**SPECIAL CONCEPTUAL WORKSHOP AGENDA
TOWN OF LADY LAKE, FLORIDA
NOVEMBER 17, 2025**

- 1. Growth Management** — Consideration of Commercial Design and Landscaping Waivers for the Florida Credit Union New Major Site Plan MJSP 08/25-002 – Proposing a 5,944 square foot bank with 37 parking spaces on 1.77 acres, zoned Planned Unit Development (PUD), located at the southwest corner of the intersection of Hammock Oaks Boulevard and Highway 466 within the Hammock Oaks Commercial Park, within the Town Limits of Lady Lake, Florida. (Becky Higgins)

RE: Permit # SPA25-000019 | Florida Credit Union Lady Lake

Town Planner Review

A-5A

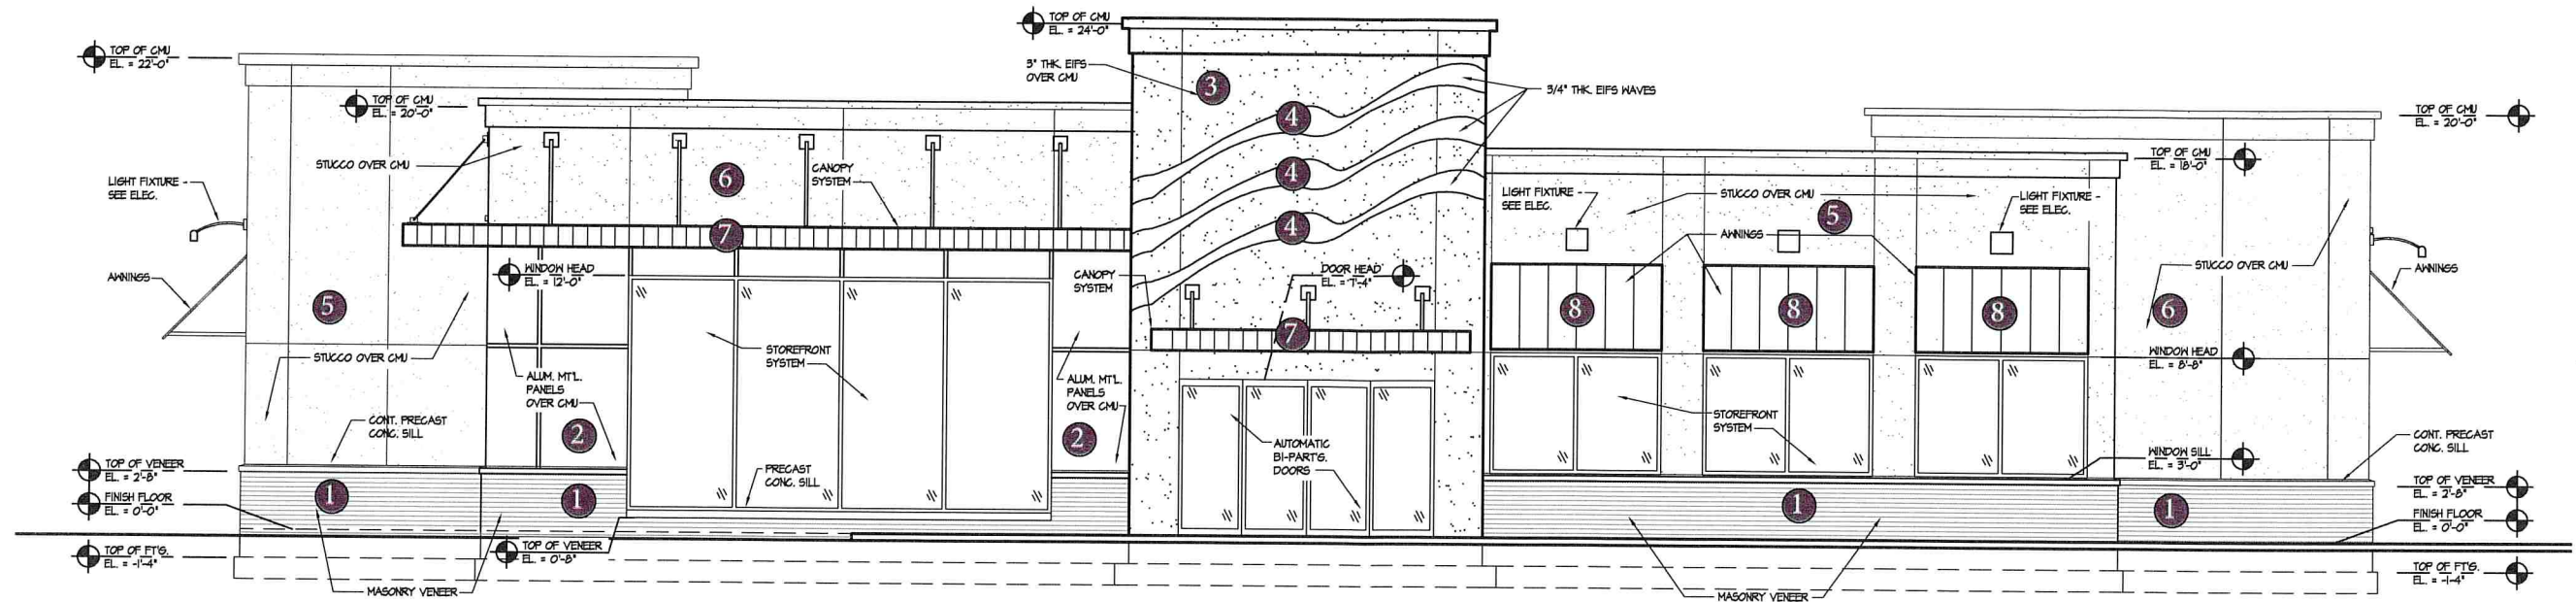
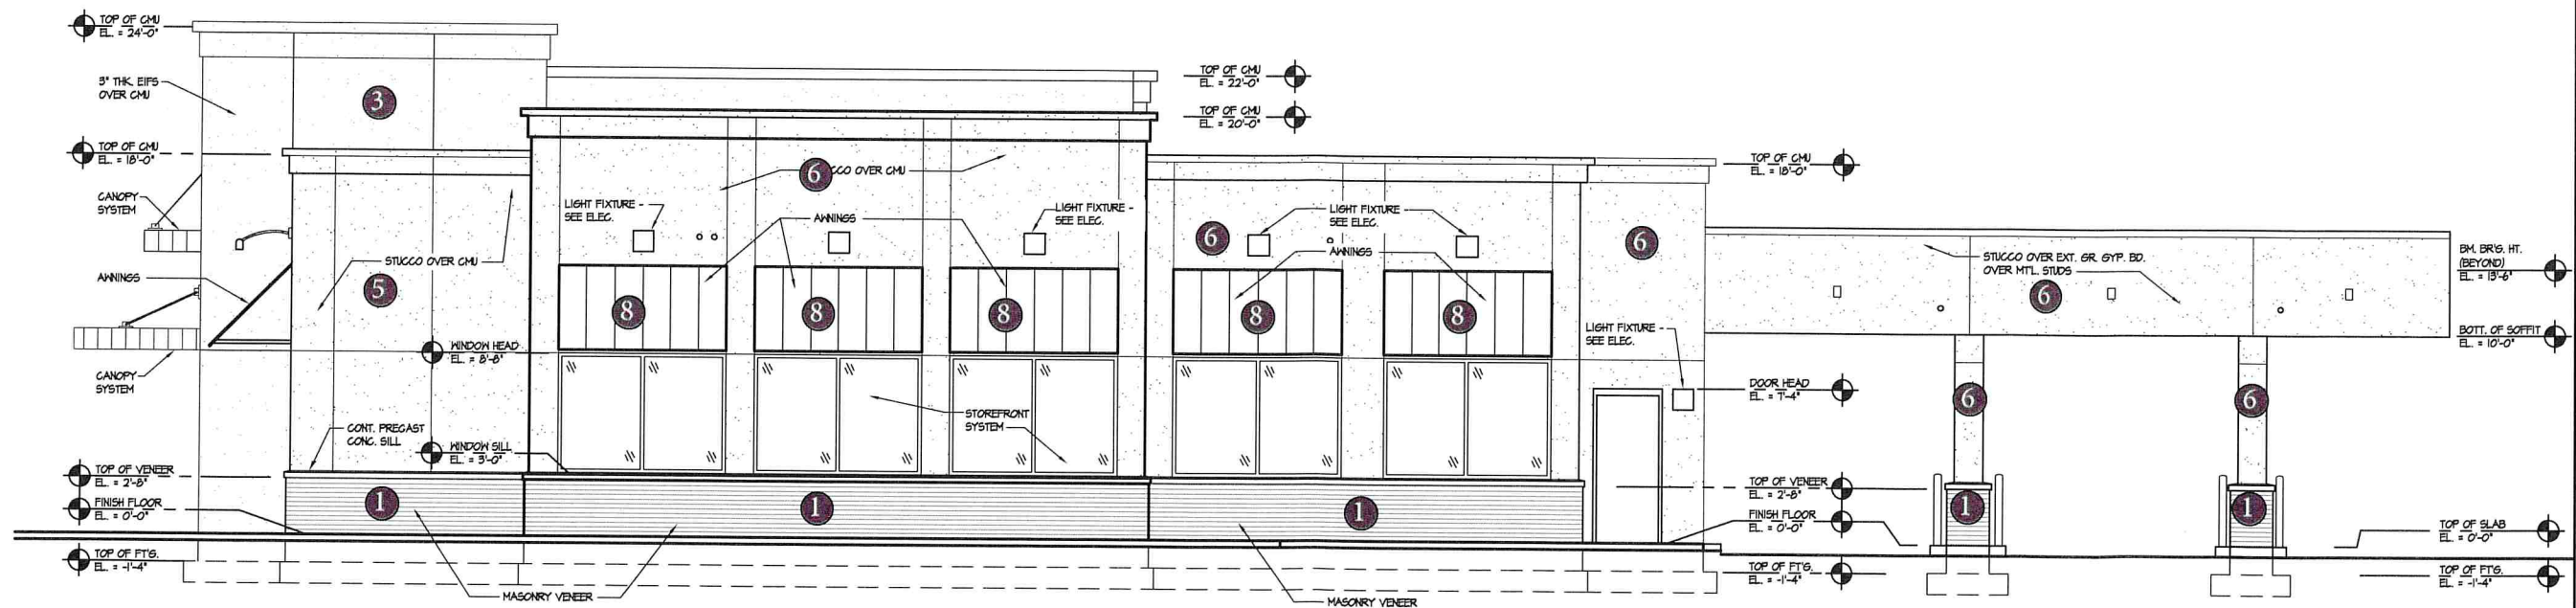
6. Correction Required: Sec 20-3C)10)N) – No more than three (3) different colors or color shades (one primary/body color, and no more than two (2) accent/trim colors) should typically be used on a single building. – Please list materials proposed and provide names for colors.

- Please refer to the attached supplemental information Architectural Sheets A-4A and A-5A that show the various materials and colors for the exterior elevations. Also, please refer to the attached four attached photos labeled FCU Exterior Elevation 01, 02, 03 and 04, which are images from an identical FCU Branch Building recently constructed in Wildwood, Florida. We thought these photos would be helpful to understand what the proposed Exterior Elevations are planned to look like at the FCU Branch Building in Lady Lake.
